STATE OF VERMONT AGENCY OF TRANSPORTATION

PROPOSED IMPROVEMENT BRIDGE PROJECT TOWN OF RICHFORD COUNTY OF FRANKLIN BRIDGE NO. 41 ON TOWN HIGHWAY NO. 2

RECORD PLANS	
CONTRACTOR	BLOW & COTE - MORRISVILLE, VT
RESIDENT ENGINEER	CARL GLEASON
CONSTRUCTION BEGAN	MARCH 7, 2008
CONSTRUCTION COMPLETE	MAY 5, 2009
RECORD PLANS BY	CARL GLEASON
I HEREBY CERTIFY THAT ALL THE CONSTRUCTION REQUIRED BY THIS SET OF DRAWINGS HAS BEEN ACCOMPLISHED AS INDICATED HEREIN	
BY	<i>Carl Gleason</i> RESIDENT ENGINEER
DATE	6/14/10
NOTE: Any further information concerning final quantities, amounts or other details relative to this project may be found at Central Files in the electronic archives

DIRECTOR OF PROGRAM DEVELOPMENT	
APPROVED <i>Warren Tripp</i>	DATE 12/16/11
PROJECT MANAGER: WARREN TRIPP	
PROJECT NAME: RICHFORD	
PROJECT NUMBER: BHF 0302 (3) S	
SHEET 1 OF 41 SHEETS

TRUSS BOTTOM CHORD ELEVATION

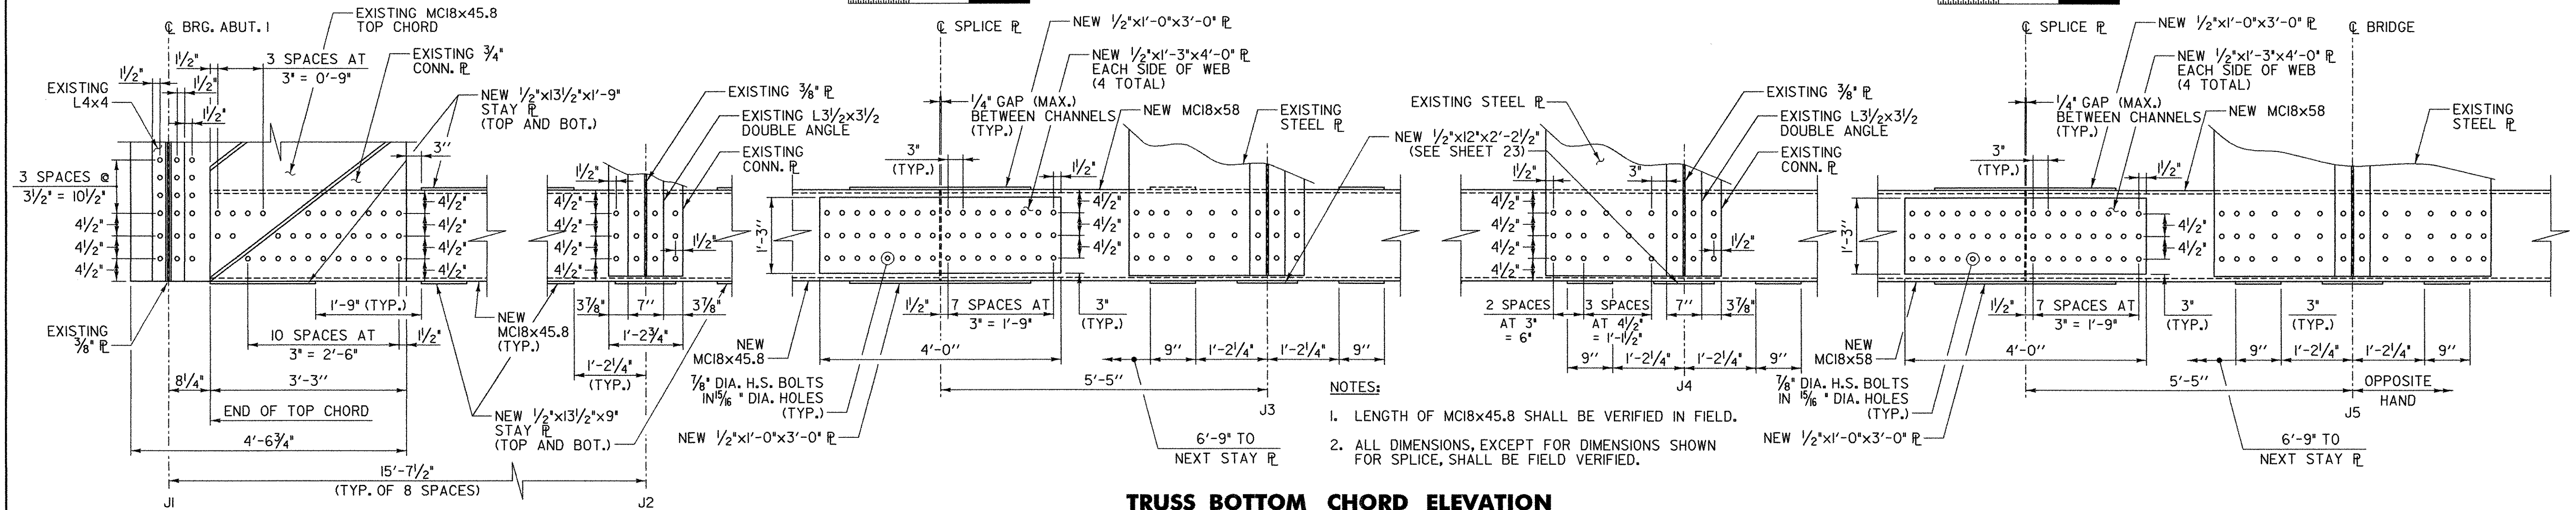
Piece Marks T11, T12, T81, and T82 (Left & Right) - Add an additional intermediate stay plate top and bottom between the top end stay plate and the first intermediate plate stay plates (top & bottom) at 10'-0". Add an additional stay plate top and bottom between the intermediate stay plate located at 19'-4 1/2" and the splice. Please note that this missing intermediate stay plate is located at a clear distance of 6'-9" from the intermediate stay plate located 1'-2 1/4" from the truss joint. These dimensions are shown on the Truss Bottom Chord Elevation, located on sheet 24 of the contract drawings.

Piece Marks T31, T32, T61 and T62 (Left & Right) - Add an additional intermediate stay plate top and bottom between the intermediate stay plate located at 26'-1" (please verify this location, it is greater than 3.125 feet from the stay plate at 22'-4 1/8") and the splice. This missing intermediate stay plate is also located 6'-9" from the intermediate stay plate between the splice and the joint.

CUSTOMER: PARENT CONSTRUCTION INC. S.O. NUMBER: 60630 DRAWING NUMBER: 5057

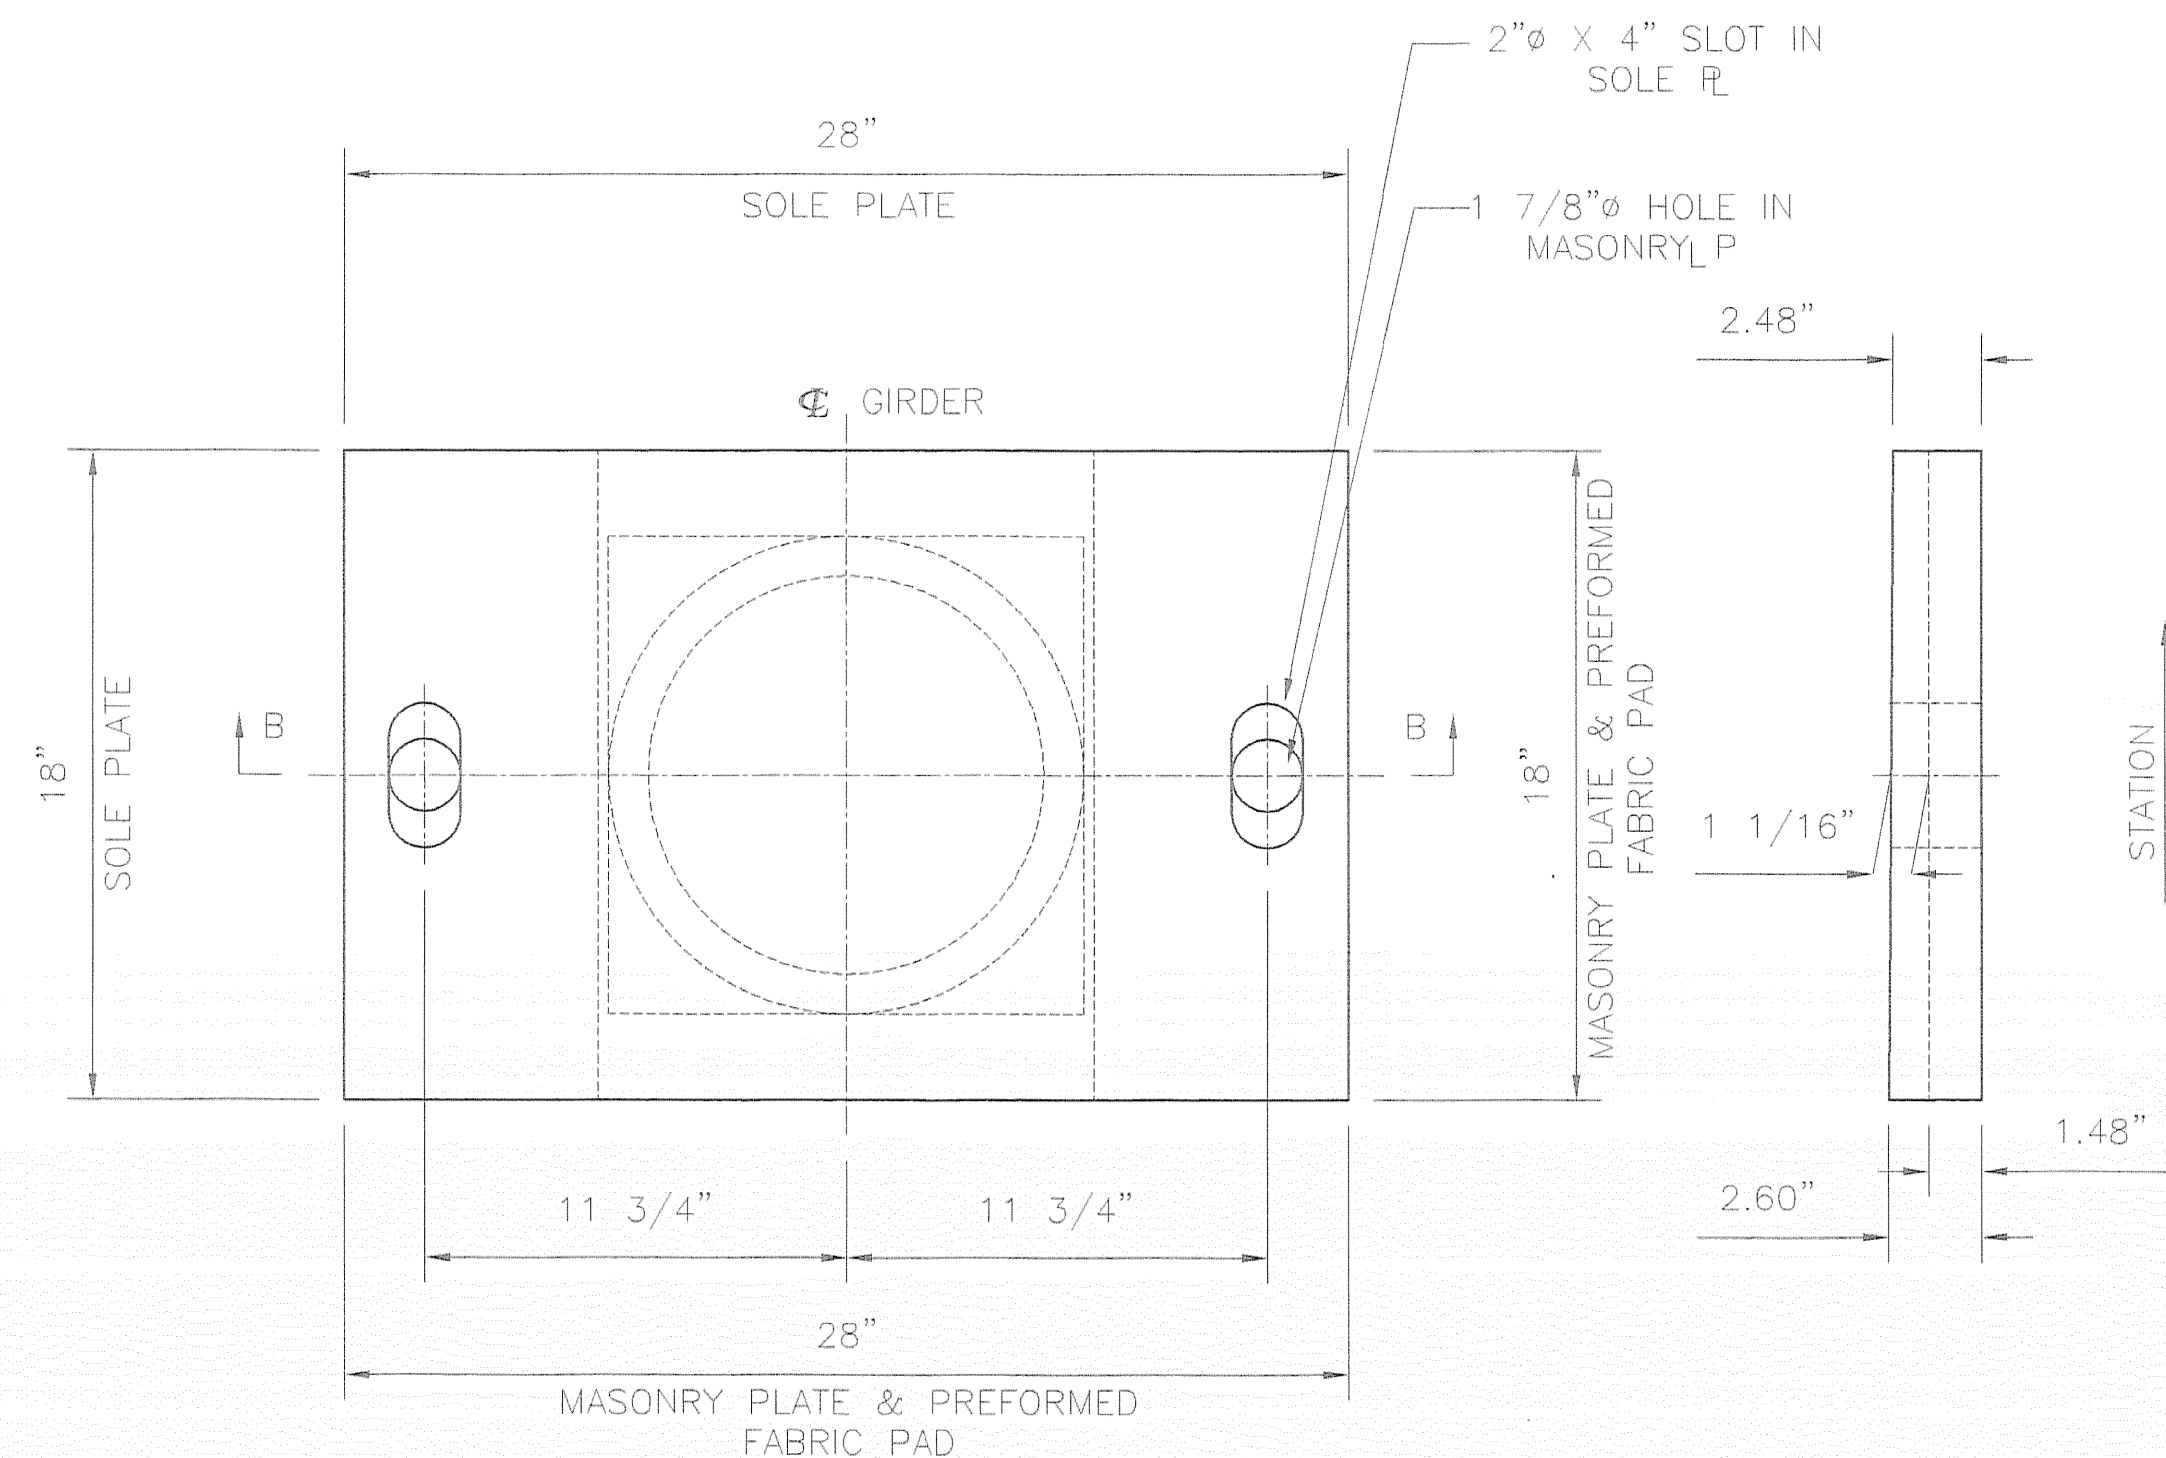
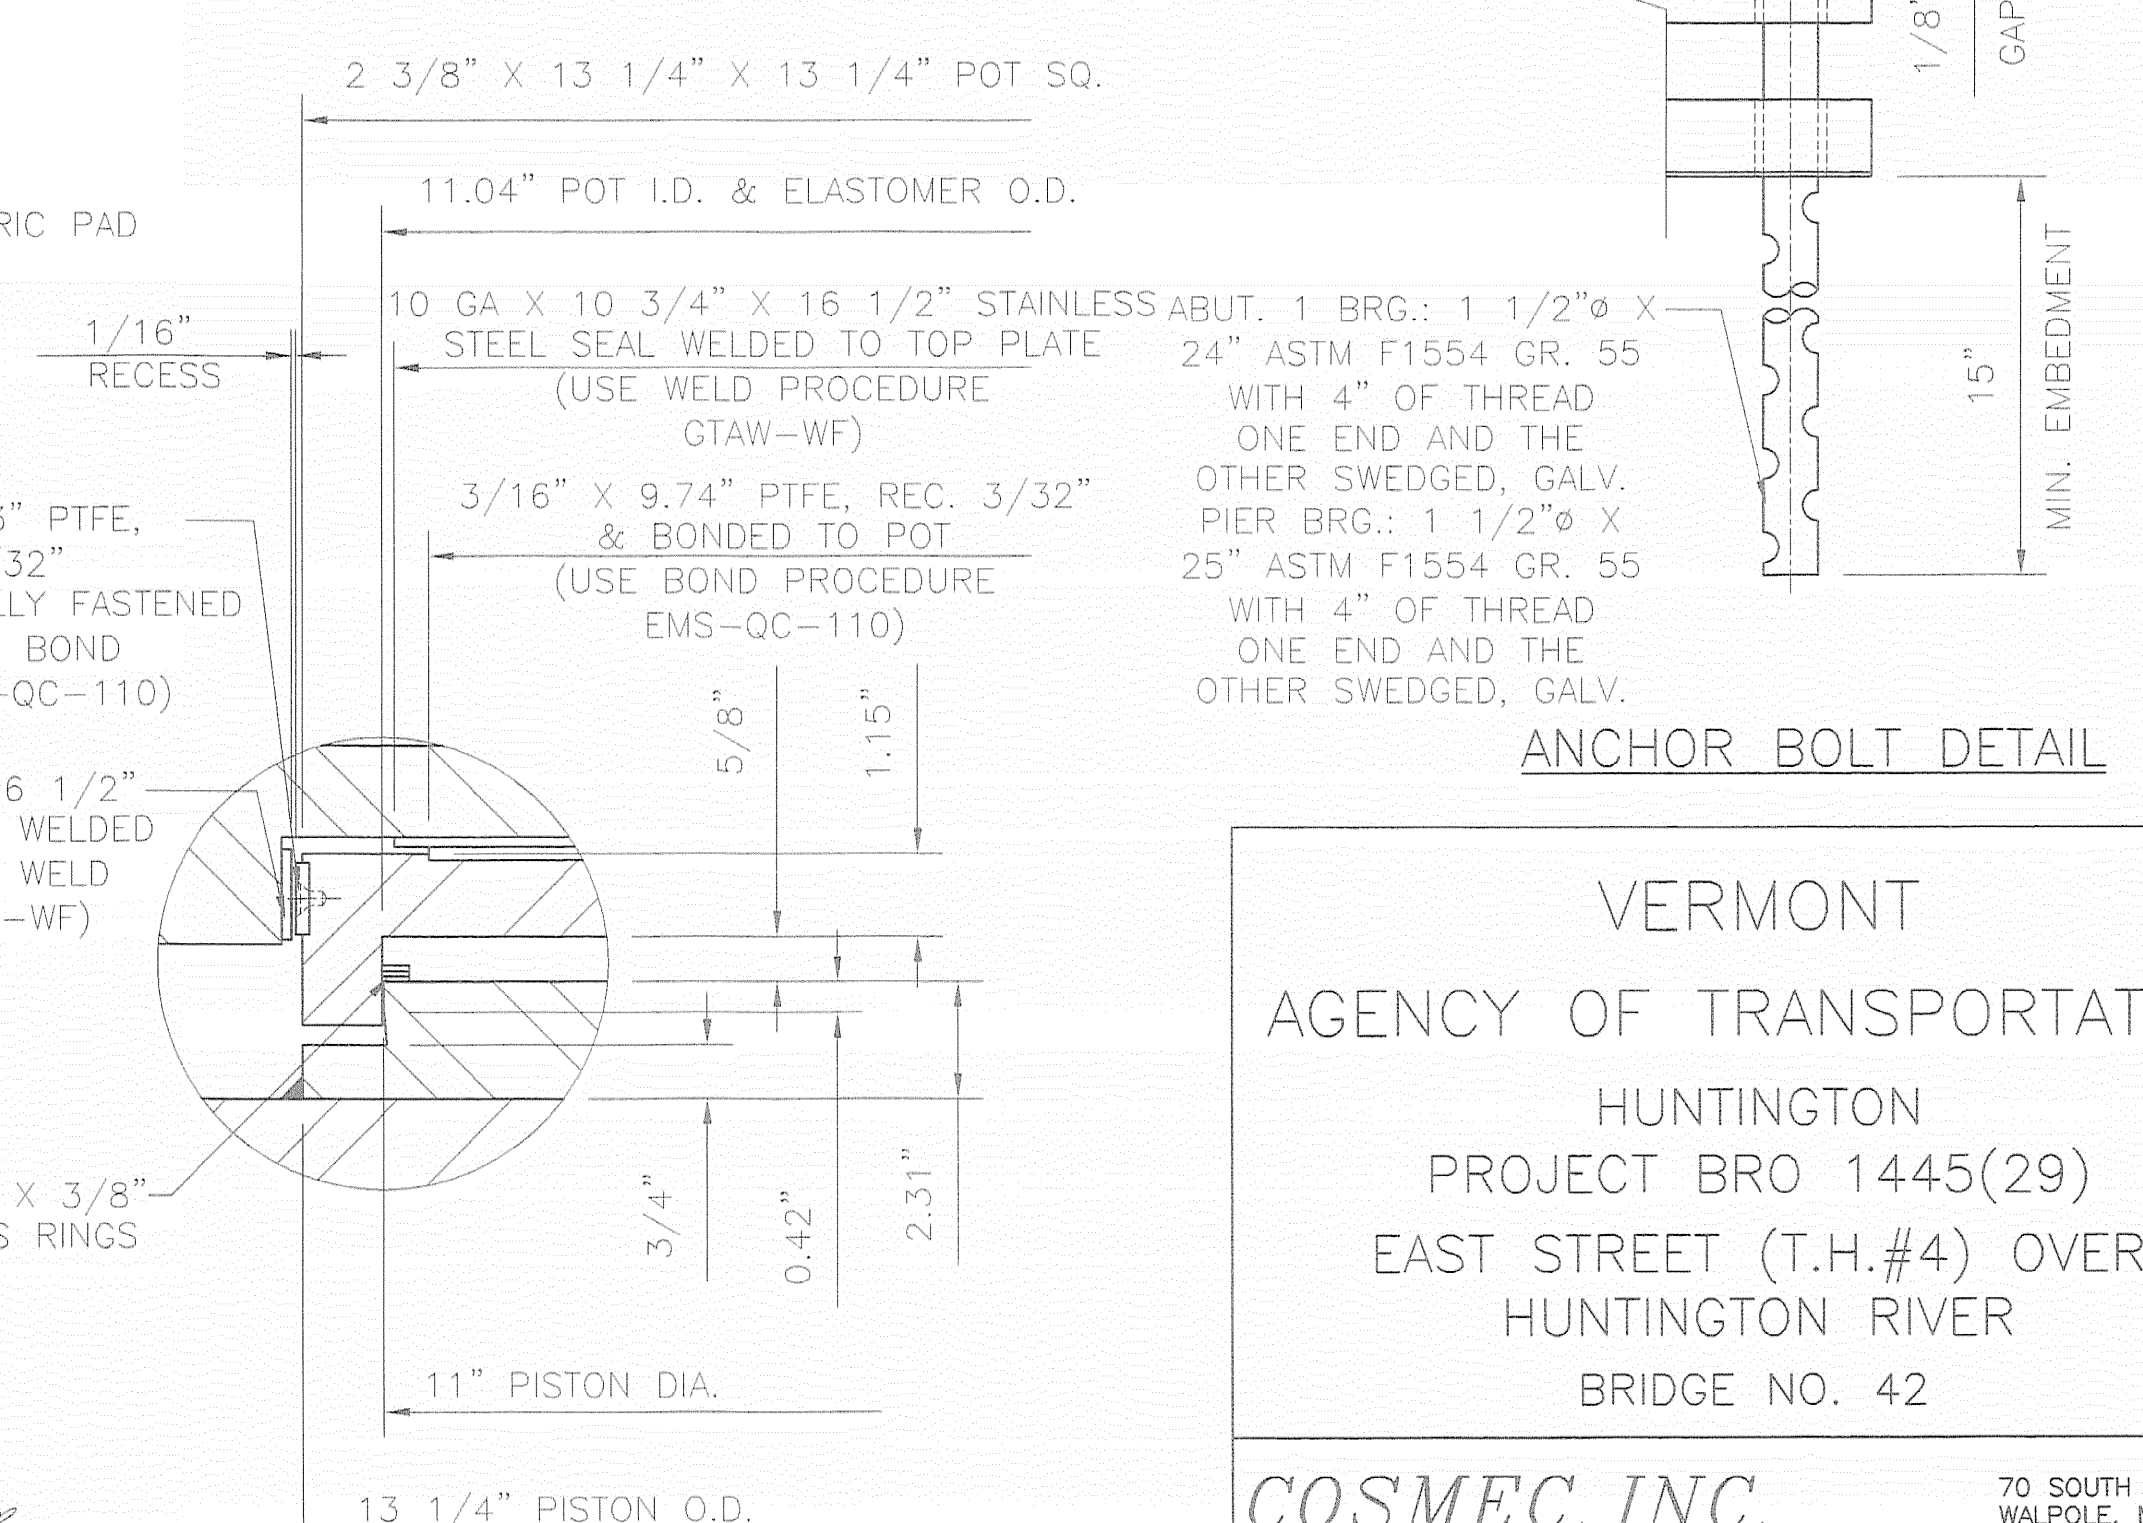
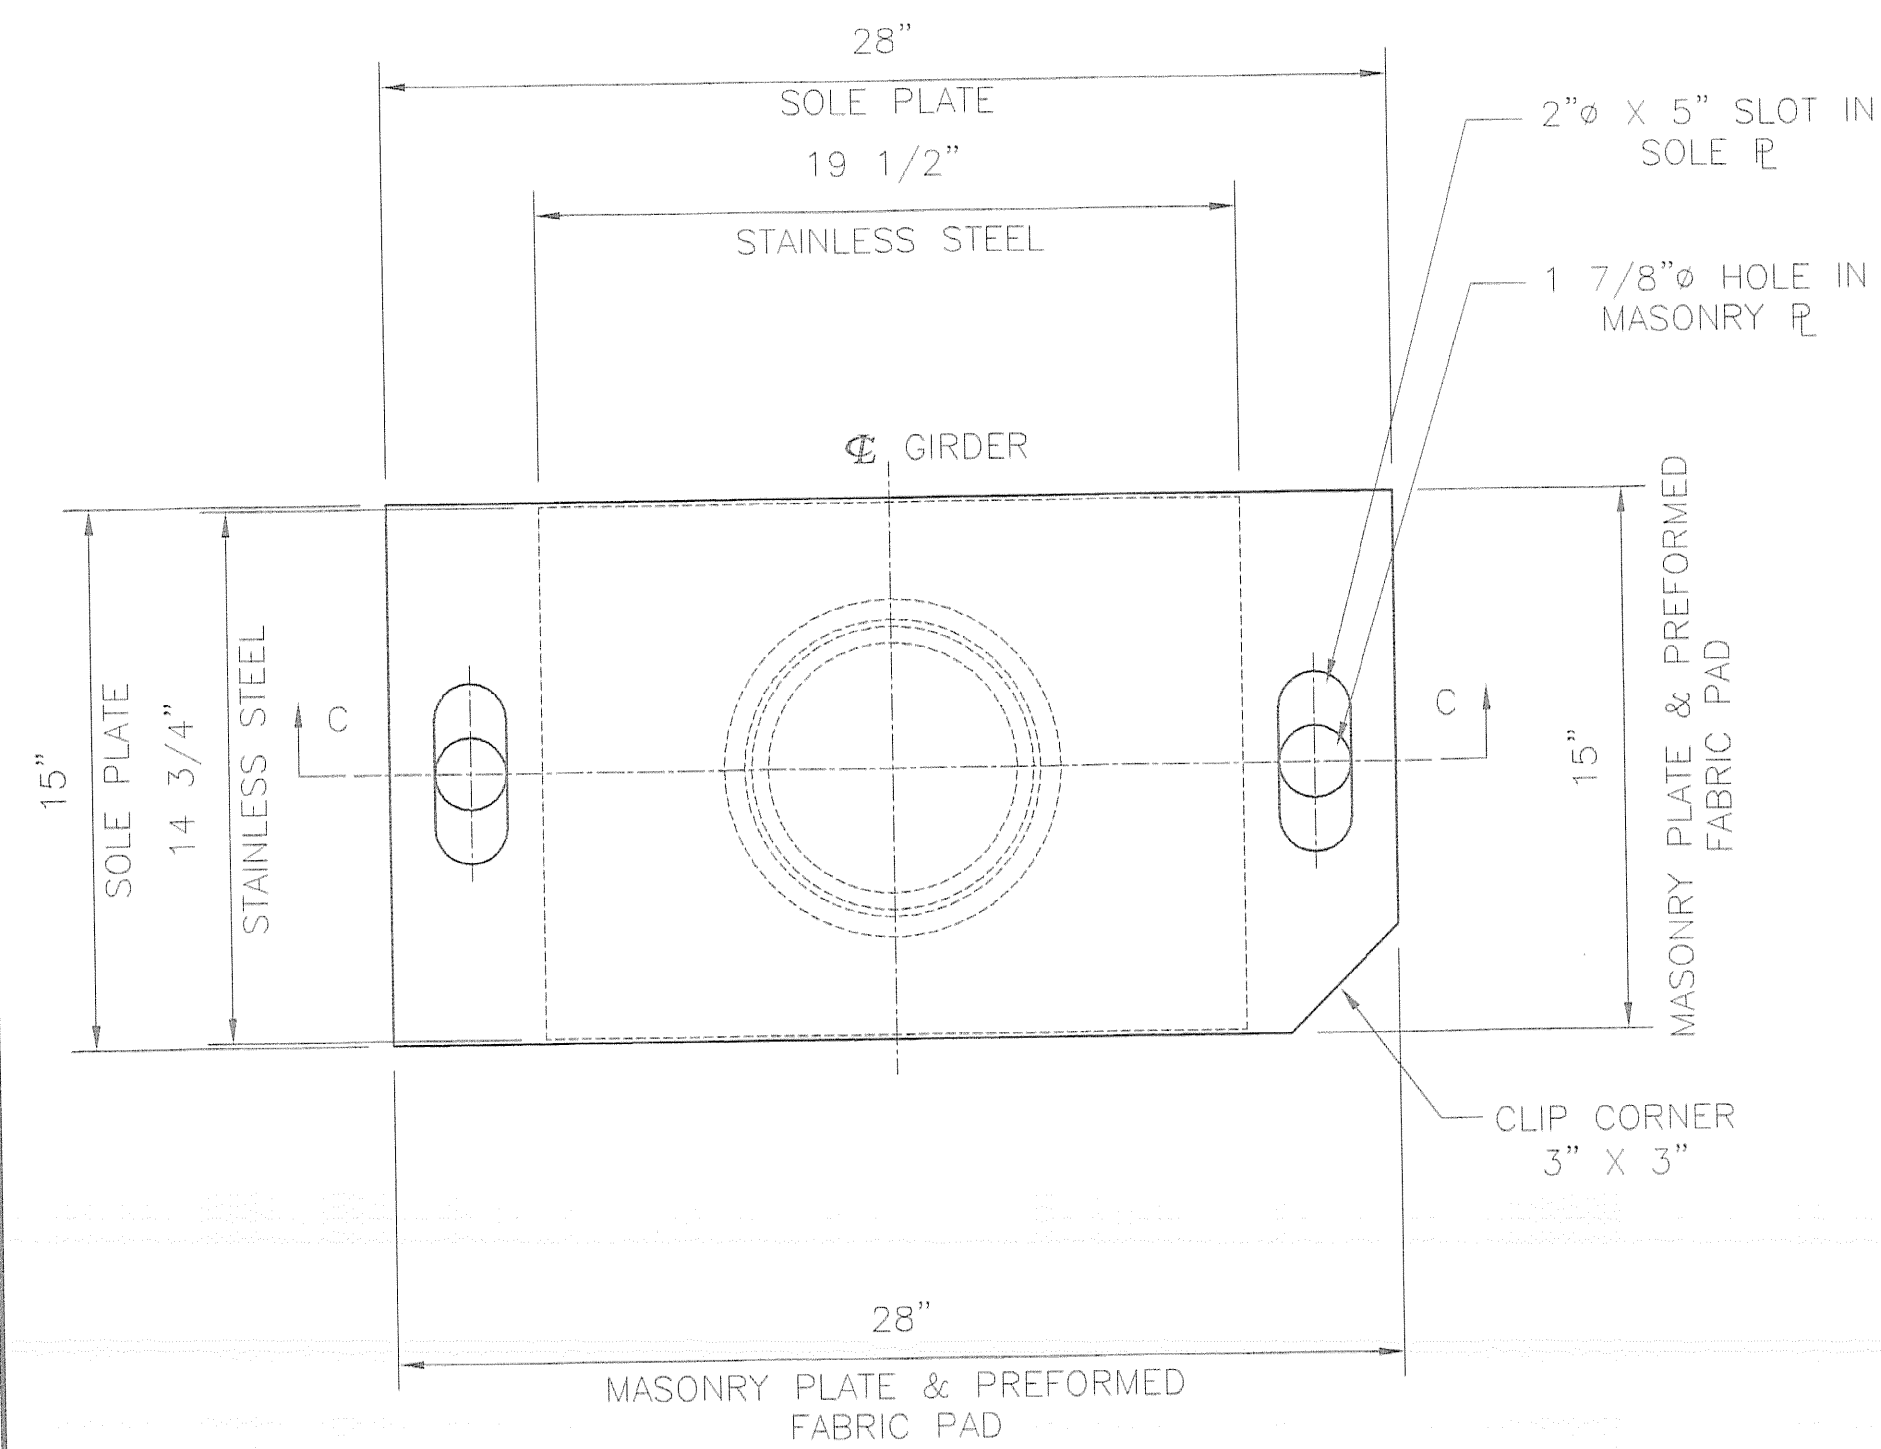
Plan Sheets Number 5057, 5058, and 5059, Welding Procedures FCAW-FILLET, GTAW-WF, and Bonding Procedure EMS-QC-110 **are approved**. If any changes are made to any of these sheets, please submit white prints for our use in record plans for this project. Otherwise, our file copy will become the record set.
